Docket Item # 4
BAR CASE # 2009-0142

BAR Meeting
July 22, 2009

ISSUE: Addition/Alterations
APPLICANT: Stephen Kulinski for Alabama Ave LLC
LOCATION: 427 North West Street
ZONE: RB/Residential

Figure 3: Existing and proposed front facade.

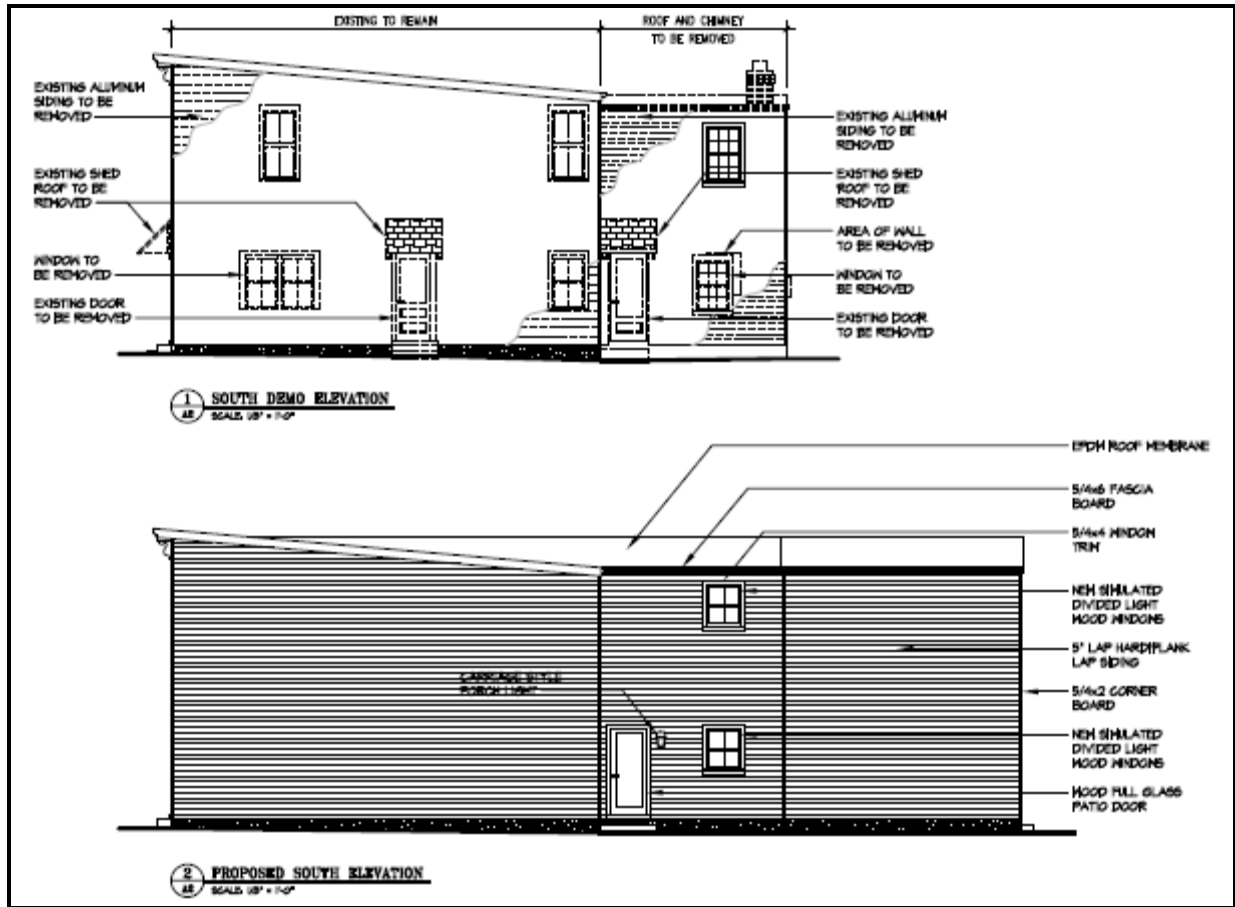
The *Design Guidelines* recommend that shutters be installed only when they are appropriate to the period of the structure. In the opinion of Staff, although the shutters provide visual interest on a rather plain façade, they are not historically appropriate on a house of this age. This is consistent with a number of other houses dating from the early 20th century in the immediate vicinity which do not have shutters (the townhouses at 401 through 411 North West Street are just one example).

- new addition, provided that the nails not show in the installation of the siding;
3. That if the subdivision of the lot does not go forward or is denied, the existing window openings on the south elevation of the main block are retained;
 4. That the applicant install single-glazed, two-over-two, true divided light wood windows on the front façade and south elevation of the main block, if those windows are retained;
 5. That the shutters on the front façade be deleted;

Figure 4: Existing and proposed south elevation.

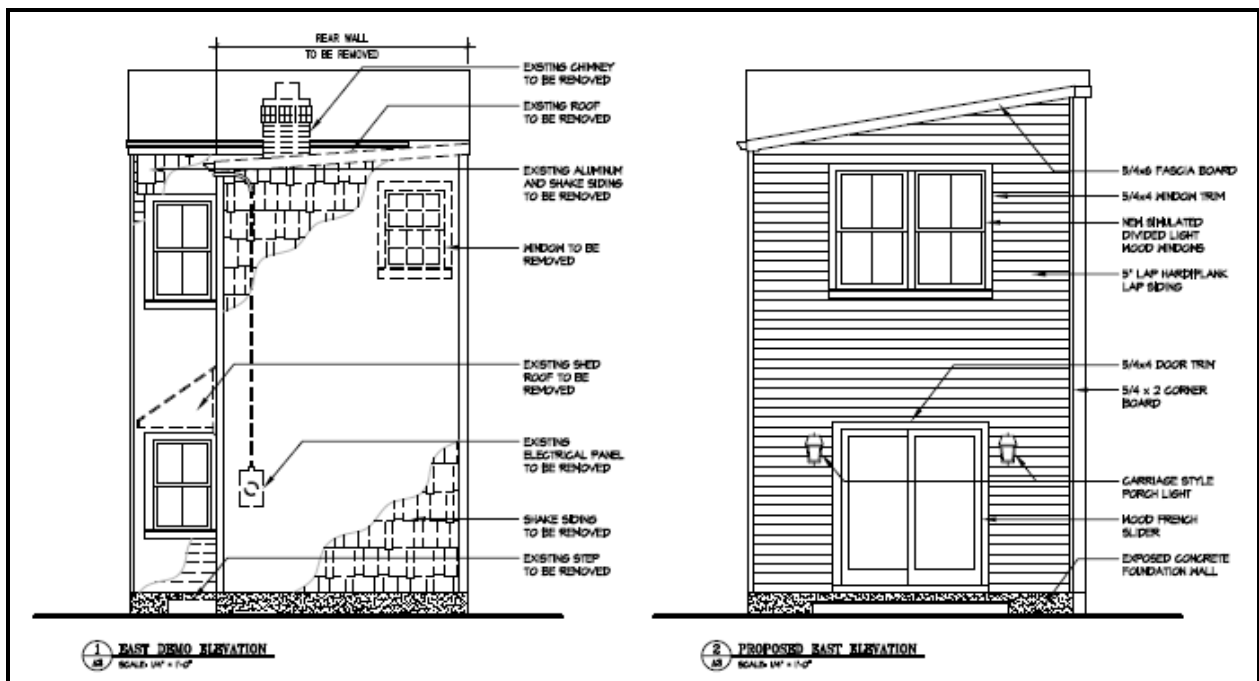
Staff believes that the removal of the windows on the south elevation of the main block is proposed in anticipation of the potential subdivision of the property and the construction of an adjacent house. However, should the subdivision not go forward or if it is denied, Staff recommends that the window openings on this elevation be retained in order to maintain the historic fenestration pattern on what is a highly visible elevation. Staff supports the removal of the door at this location.
